## HIGHLIGHTS FROM FEMA REPORT VS WILLOWBROOK AND

### FEMA PICTURES - Lack of adequate connections

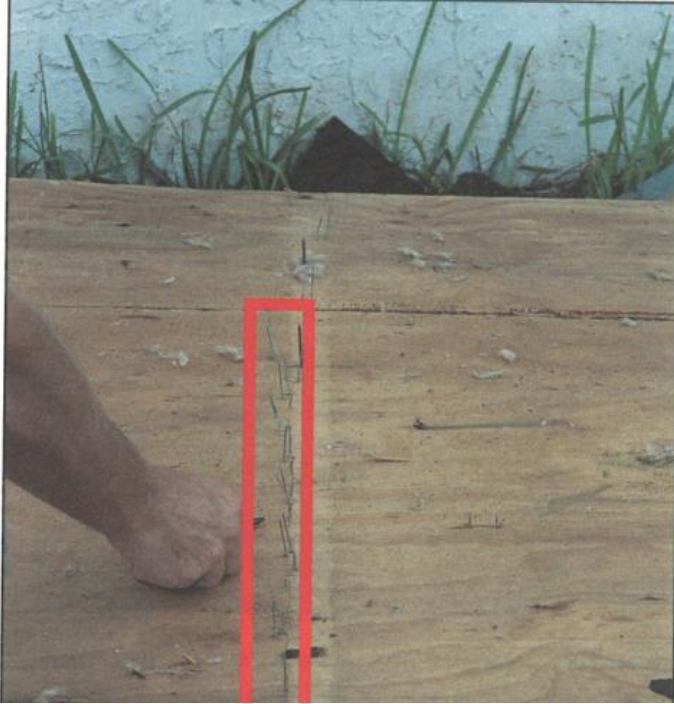
FIGURE 11.  
*Roof sheathing found in debris. Staples were off-line and therefore not connected to supporting truss top chord.*

FIGURE 10. *Top plate splice not able to transfer horizontal loads.*

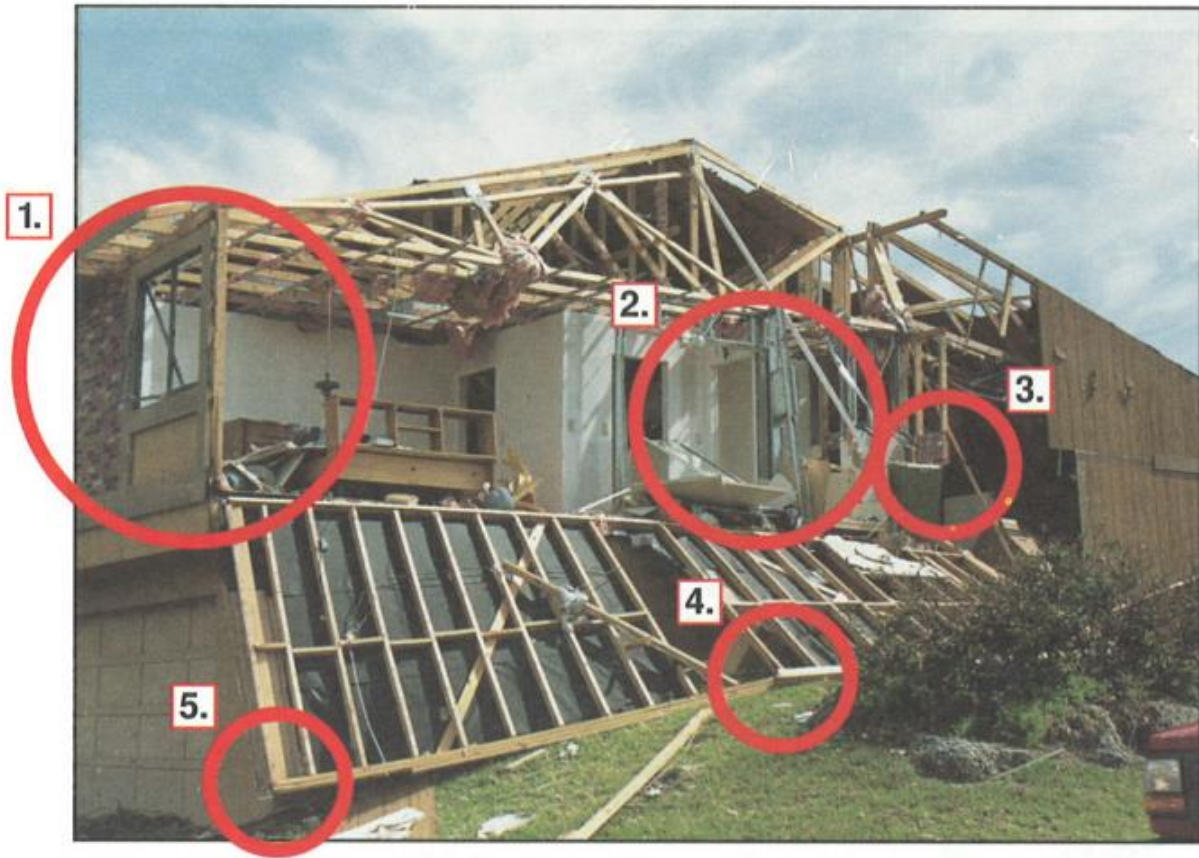
FIGURE 9. *Failure of non-loadbearing wall. Connections of exterior wall were not adequate.*

- 1. End column separated from roof.*
- 2. Load transfer from outside wall to interior shear wall inadequate.*
- 3. Beam separated from beam seat/connector.*
- 4. Improperly spliced composite tie-beam/connector.*
- 5. End of top plate connection inadequate.*

FIGURE 15. *Masonry construction building. Wall separated from building envelope due to inadequate vertical wall reinforcing in connection to horizontal tie-beam.*

FIGURE 14. *Roof structure failure due to inadequate bracing.*
